DESCRIPTIVE REPORT.

*Hyd.* Sheet No. **4044**

*Morro Bay*

Morro Bay, California

Sheet 2

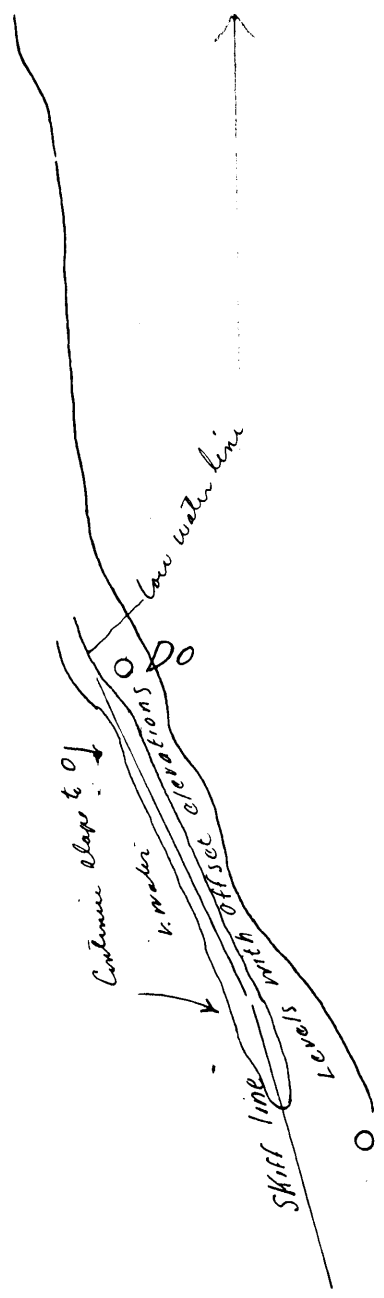
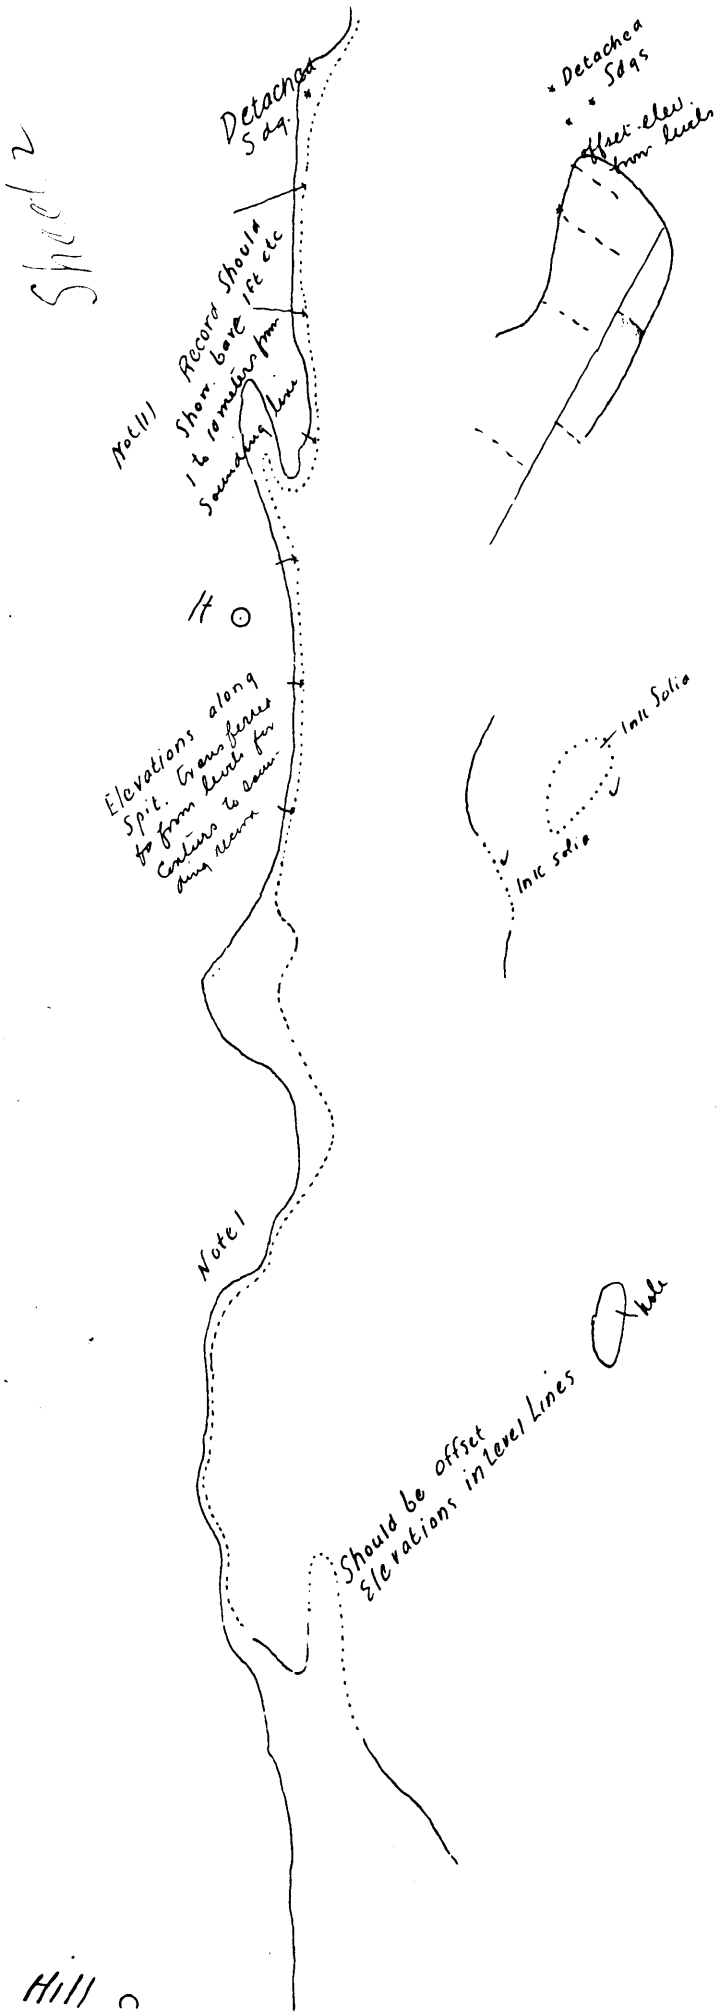
Low water line where 0. ft  
comes continuing slope as indicated

SHEET  
4

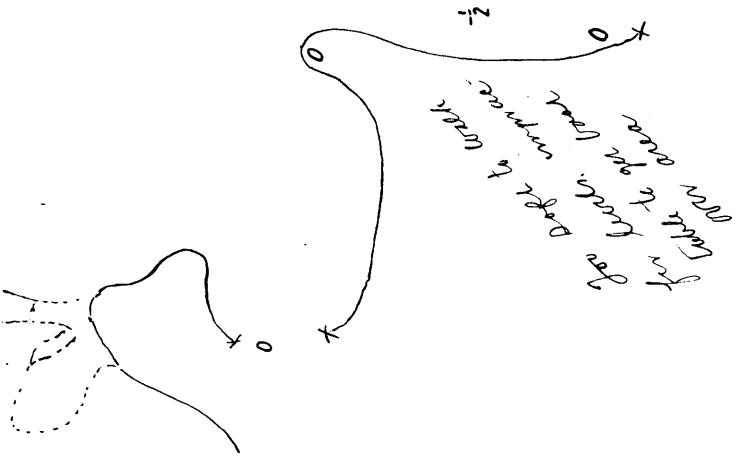
Several attempts made to get additional lines

Levels by Wickett from notes to bounding lines  
 See notes on the line  
 notes  
 Mid

Sheet 6

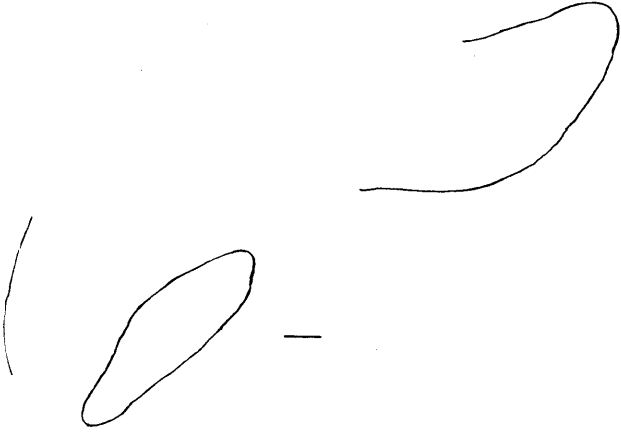
See notes as to edge of line  
 6ft  
 6ft

See notes as to  
 edge of line  
 6ft  
 6ft
